RFP Questions and Clarifications Memorandum

To: Vendors Responding to RFP Number 3740 for the North Mississippi State Hospital (NMSH)
From: Craig P. Orgeron, Ph.D.
Date: April 24, 2014
Subject: Responses to Questions Submitted and Clarifications to Specifications
Contact Name: Chris Grimmer
Contact Phone Number: 601-432-8208
Contact E-mail Address: chris.grimmer@its.ms.gov

RFP Number 3740 is hereby amended as follows:

SHEET NUMBER
S101
 OF 143

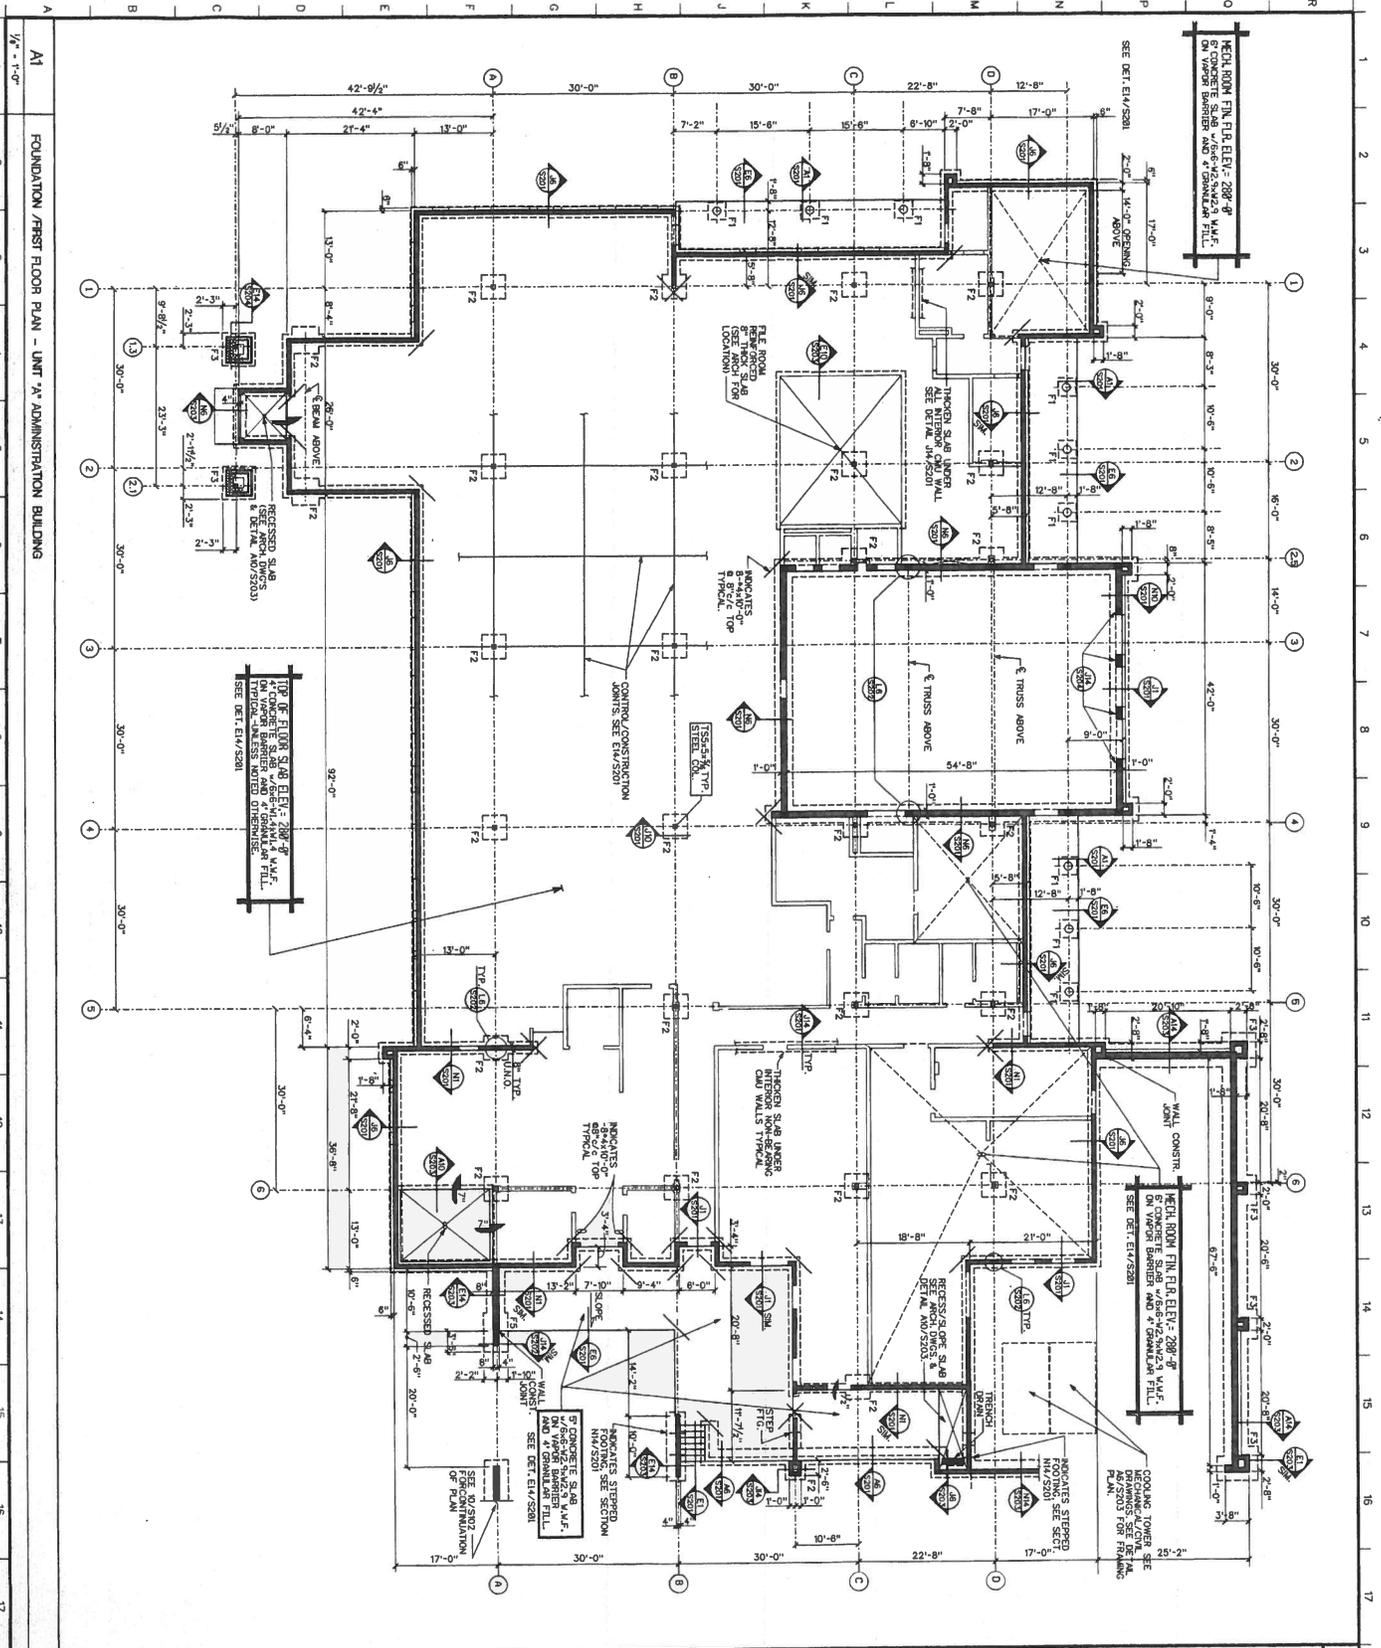
Question 16: Since the drawings are not to scale can you provide a few dimensions? This would be very helpful in determining cable footages and lens choices.

A. Building dimensions for each building

B. Distance from Admin Bldg. to vehicle gate by warehouse

C. Distance from Warehouse to Farm Equipment fenced-in area

Response: The Maintenance\Warehouse Building is approximately 95' by 40' The main dividing wall is approximately 40' from the shipping dock. Refer to Clarification Number 1 of this Memorandum.

Response: **Approximately 280 ft. Refer to Clarification Number 1 of this Memorandum.**

Response: **Approximately 225 ft. Refer to Clarification Number 1 of this Memorandum.**
